U. S. NUCLEAR REGULATORY COMMISSION
REVIEW OF IDAHO NUCLEAR TECHNOLOGY AND ENGINEERING CENTER
DRAFT WASTE-INCIDENTAL-TO-REPROCESSING DETERMINATION FOR
TANK FARM FACILITY RESIDUALS

Attachment

Figure 4. Illustration of the two-dimensional modeling slice used in PORFLOW

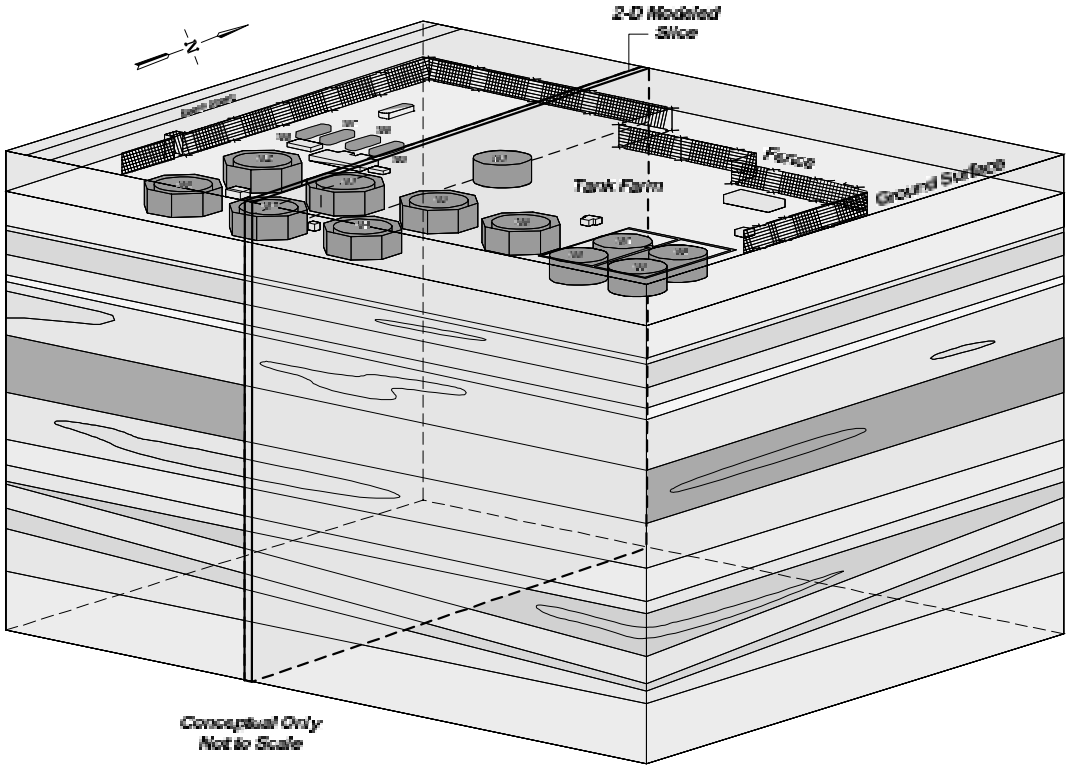
The overall modeling approach appears to be a reasonable attempt to manage uncertain hydrologic and geologic information. It appears, in general, that DOE-ID appropriately assessed the TFF transport system through use of conservative assumptions. These conservative assumptions help to simplify the transport model as well as add confidence in the output. Conceptual model uncertainty can, in some cases, significantly impact the risk when transport is through a fractured, unsaturated hydrologic system. Confidence is gained with the DOE-ID approach as a result of the comparisons of the model predictions for tritium movement with the observations [36].
